ADMINISTRATIVE AMENDMENT

PROJECT TITLE
WESTWOOD APARTMENTS
 MARKET STREET ALBUQUERQUE, NEW MEXICO
 SHEET TITLE

DRB Site Plan

SITE PLAN

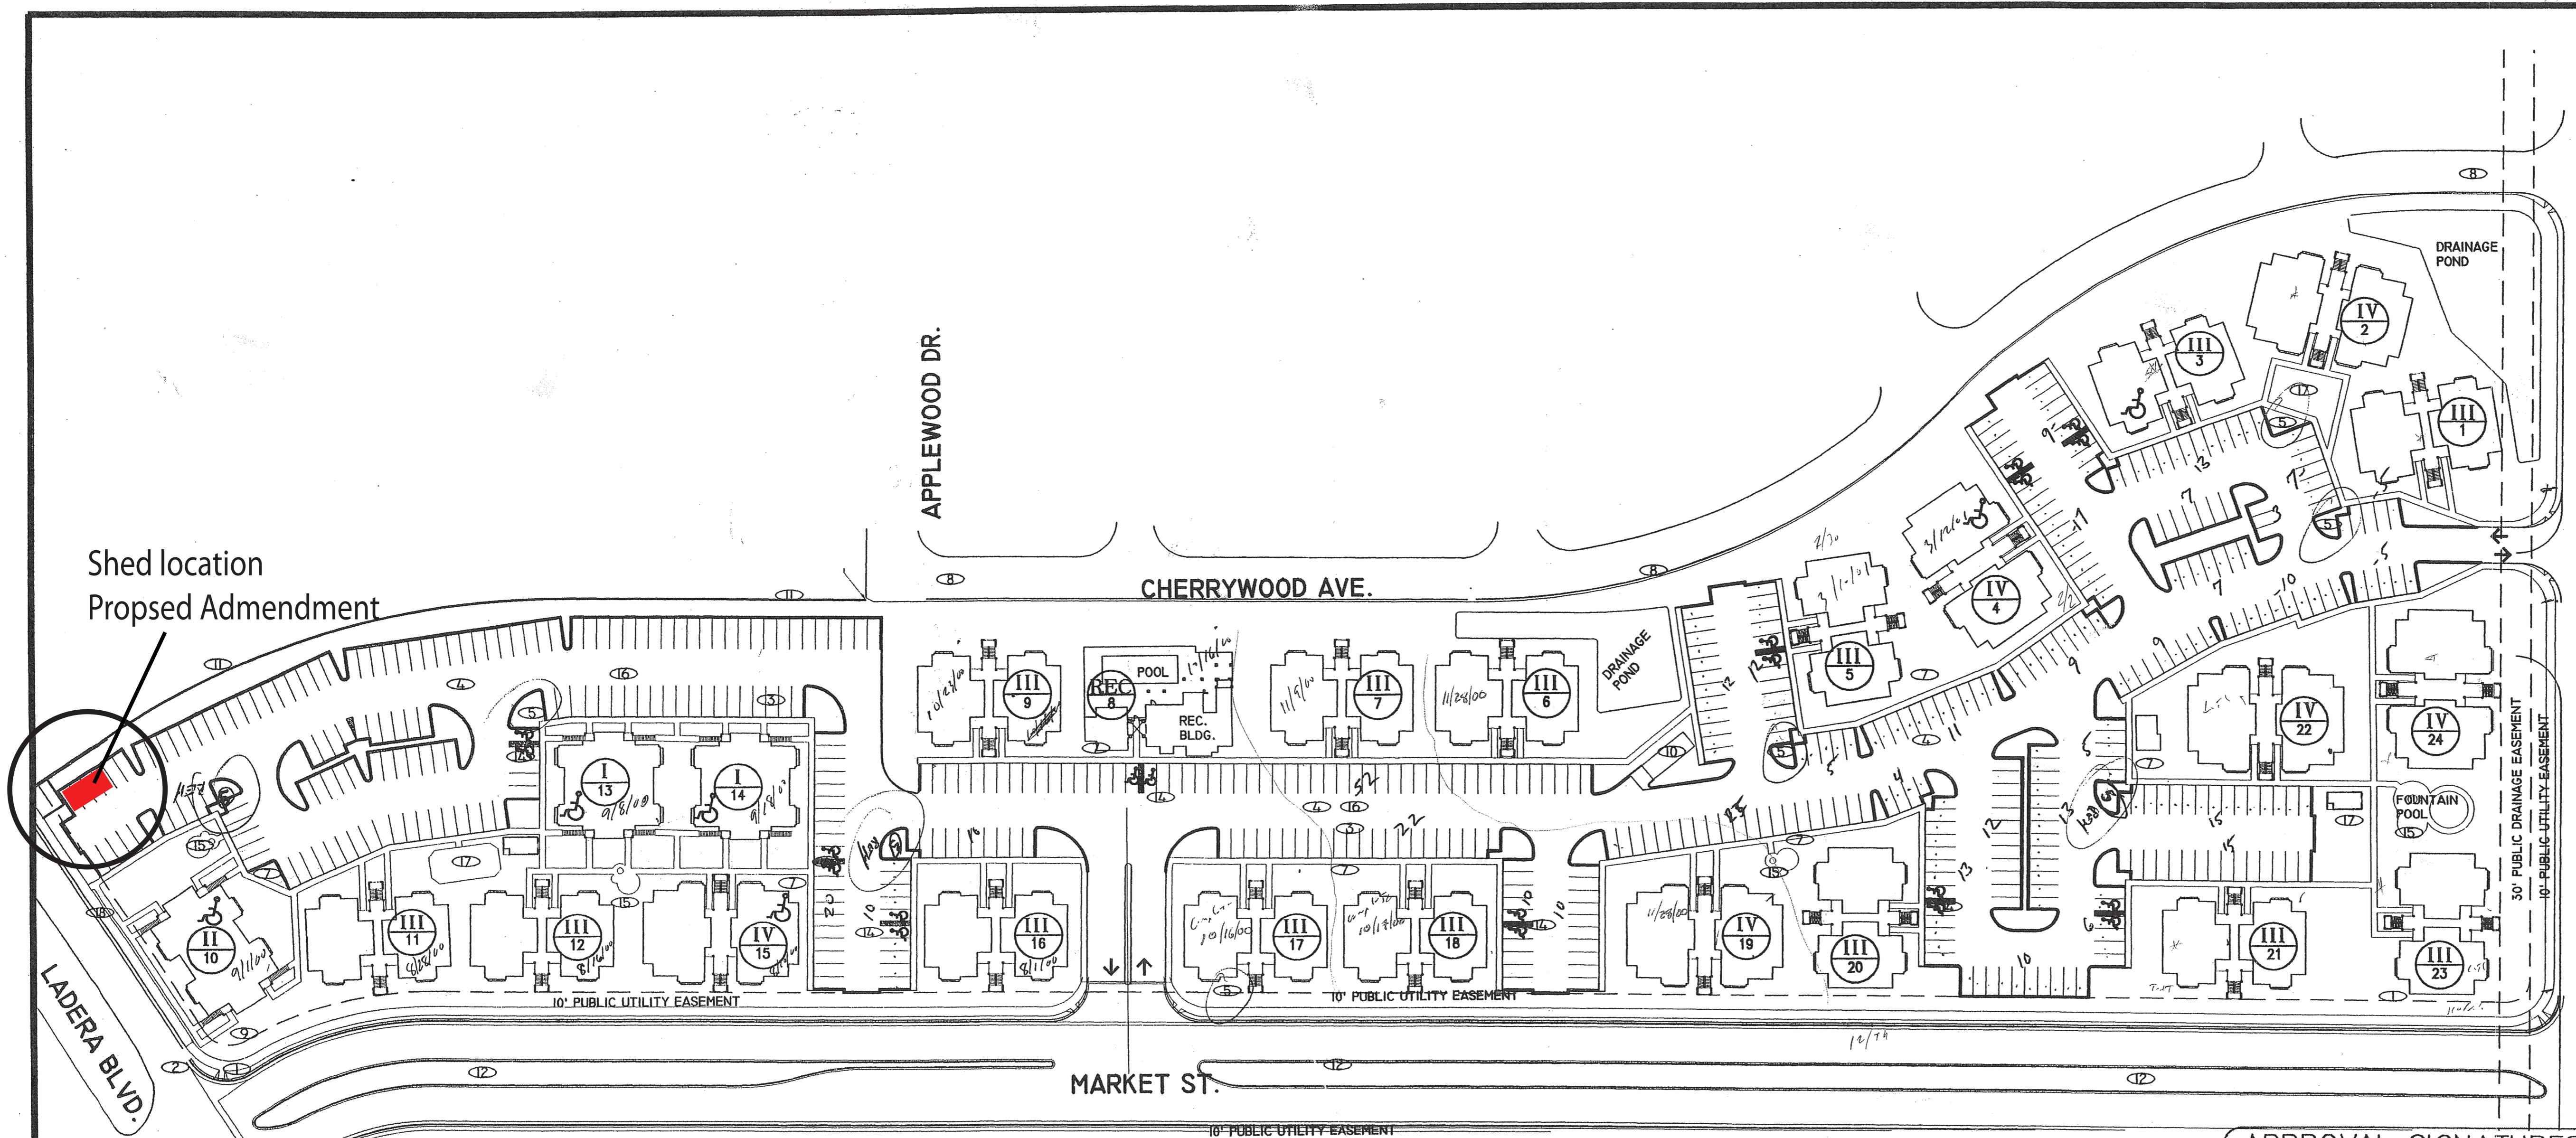
TOTAL PROVIDED PARKING = 538
 534

New Provided Parking
 Proposed Admendment

KEYED NOTES

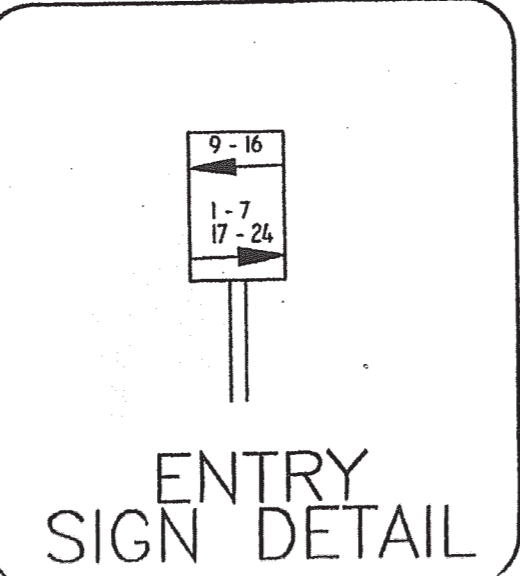
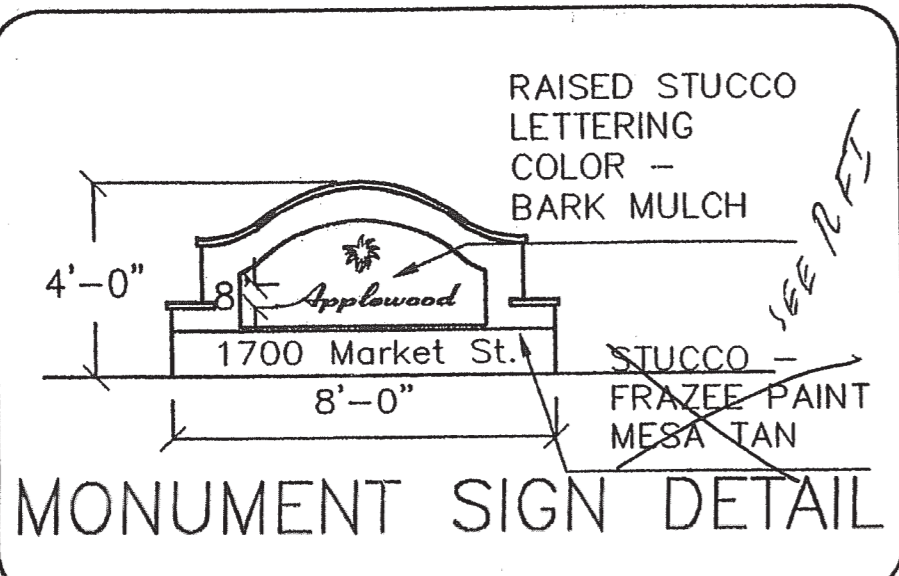
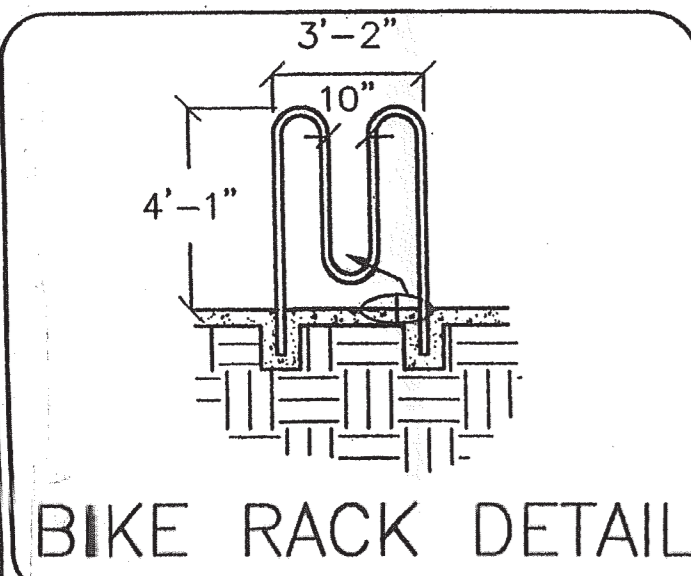
- EXISTING WALL
- PILASTER 20" ON CENTER
- 1/2" WROUGHT IRON 6" ON CENTER
- 4" WHITE SLUMP BLOCK
- WROUGHT IRON COLOR - RED / VERMILLION
 French Red per RFI # 90
